HISTORIC LANDMARK COMMISSION  
STAFF REPORT

TRACY AVIARY WILSON PAVILION  
RENOVATION, SOUTHERN GROUND  
HORNBILL'S NEW CONSTRUCTION,  
INSTALLATION OF TEMPORARY BUILDING,  
ACCEPT MASTER PLAN  
Major Alterations and New Construction &  
PLNHLC2008-00684  
Liberty Park, 589 East 1300 South  
August 5, 2009

**WILSON PAVILION RENOVATION**  
556 E. 1500 S.  
SALT LAKE CITY, UTAH 84119  
57th CONSTRUCTION DOCUMENTS  
**TRACY AVIARY**

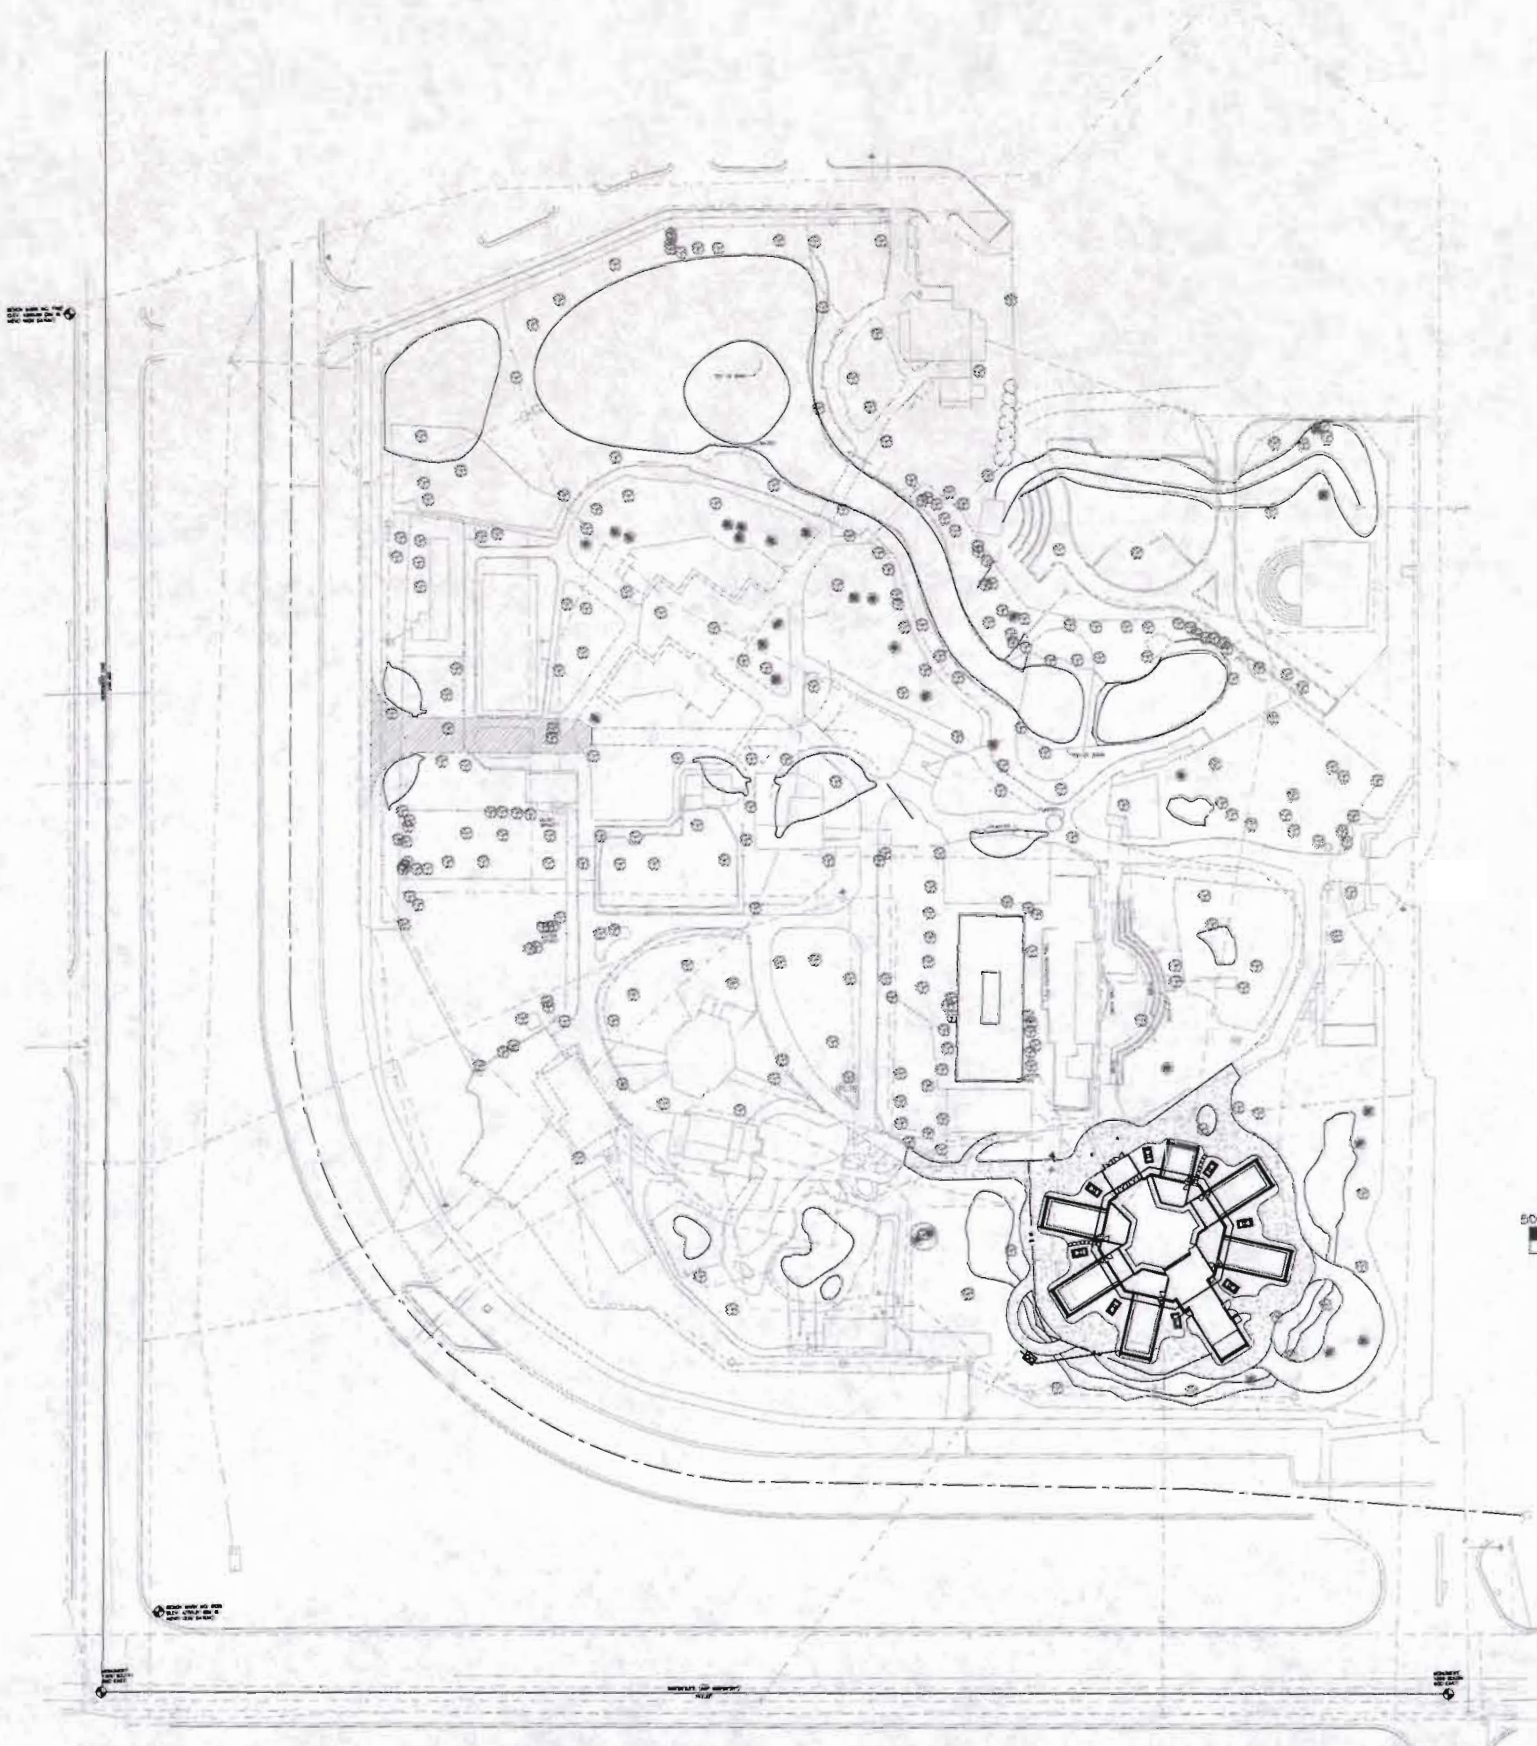
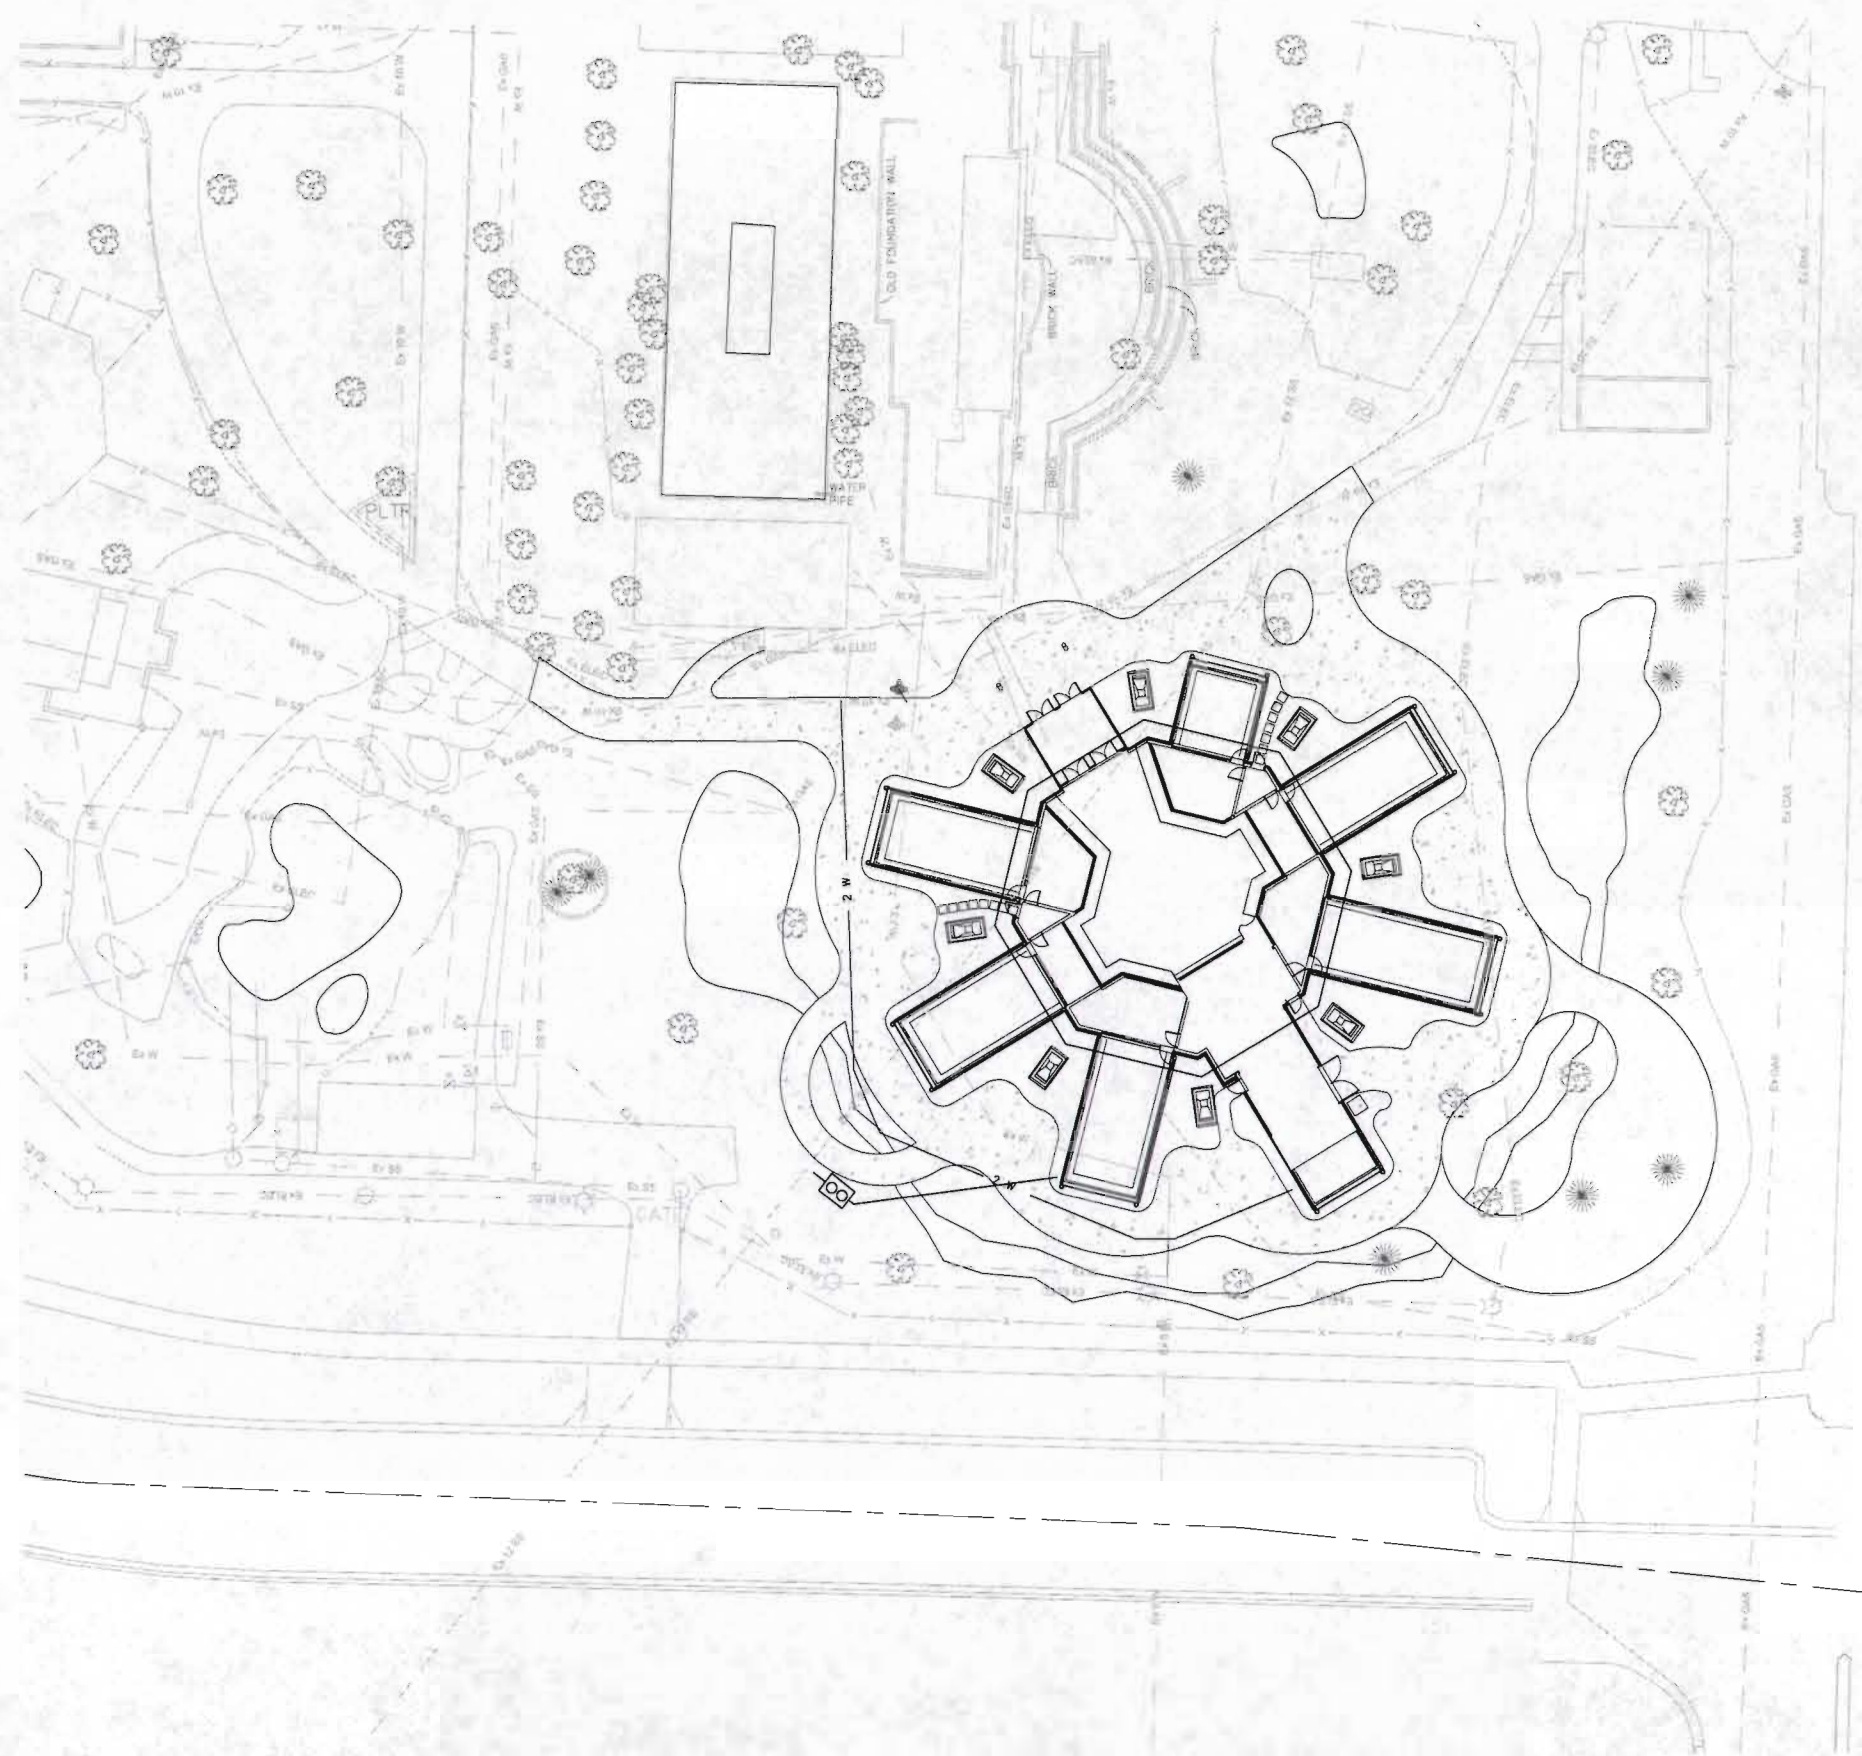
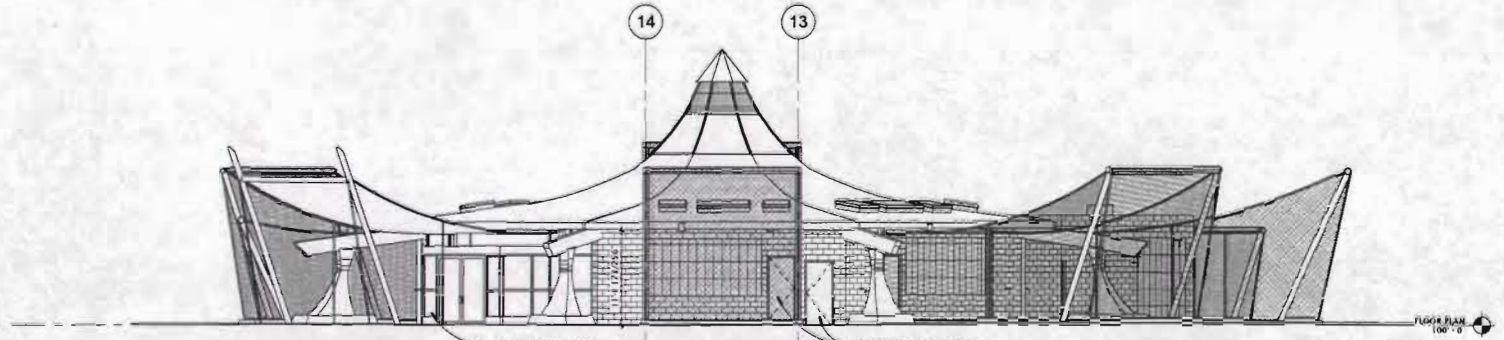
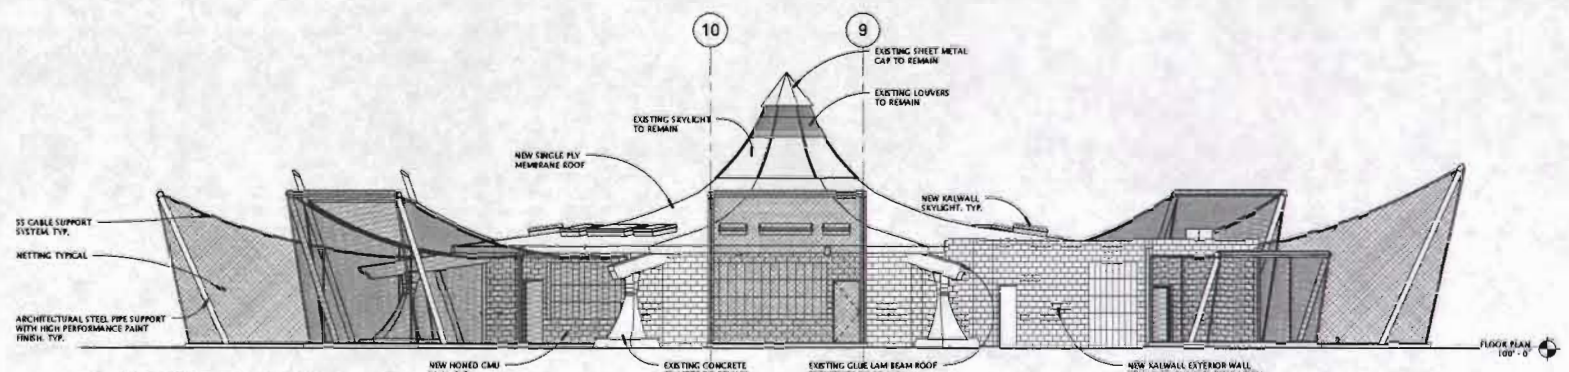
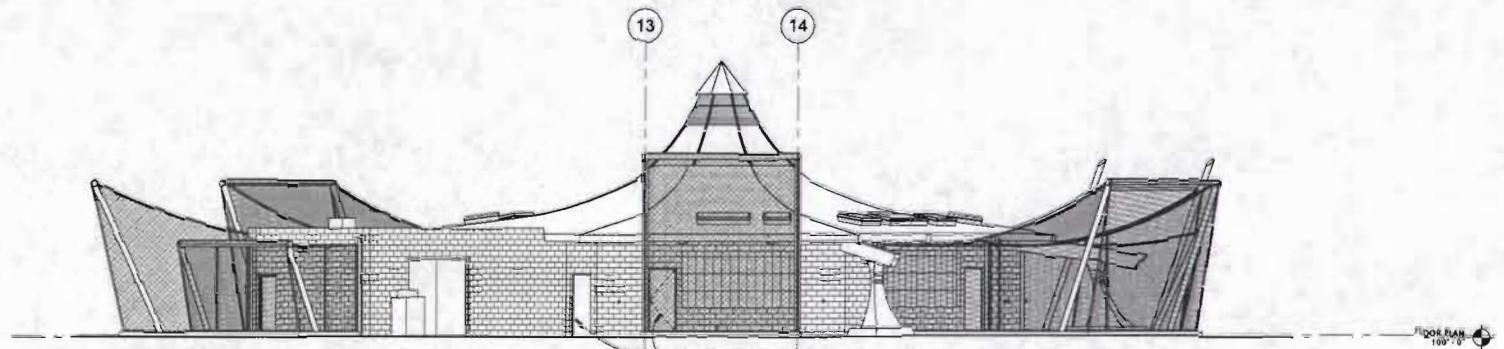
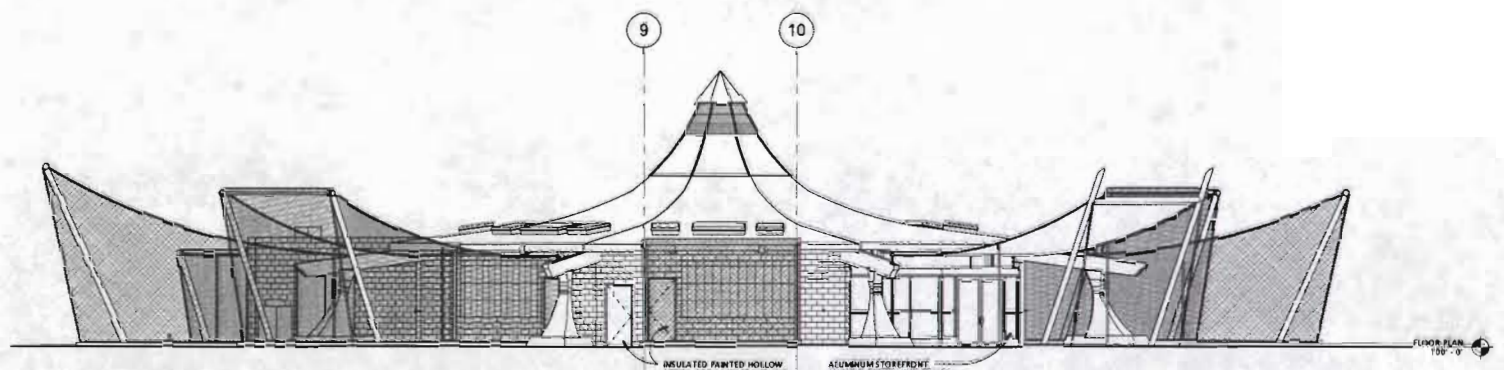
**Finding for Standard 2, 5 and 6:** Materials and features to be removed include the portions of the exterior walls which serve as rear walls to the exterior exhibits, the non-original roofing material and doors, which in the case of this structure, are not defining characteristics. The most distinctive exterior features of the building are the sweeping roofline, and the wood and concrete rafters and posts which will be retained. The roof will have additional skylights; however they will rise above the roof by only eight inches, have a flat design, and be located on the flatter portions of the roof, making them difficult to see from the ground. A secondary feature is the main entrance of the building which will dramatically change with a new location and an aluminum and glass entry vestibule of 270 square feet, topped with artwork. The existing entrance has a much lower profile than the proposed entrance which will project out from the building. Another major change for the building is a projecting rear entrance with area for mechanicals. The impact of these new entrances are somewhat mitigated by their transparent design. The project meets these standards in terms of materials, but not in terms of retaining distinctive features.

**Finding for Standard 3 and 8:** The materials help to define changes to this structure as contemporary and their transparency (glazed panels and wire mesh) allow for the original design of the building to remain apparent. The changes do not create a false sense of history as they are clearly different in design yet play off the building's original design intent. The project meets this standard.

**Finding for Standard 9:** Most of the proposed changes can be removed without damaging the essential form and integrity of the structure. The replacement of walls is a more permanent change, however the location of walls will not change and these walls are not a defining feature of the building.

**Finding for Standard 11:** Signage or artwork is proposed for above the new main entrance. There is not enough information, at this time, to review the signage.
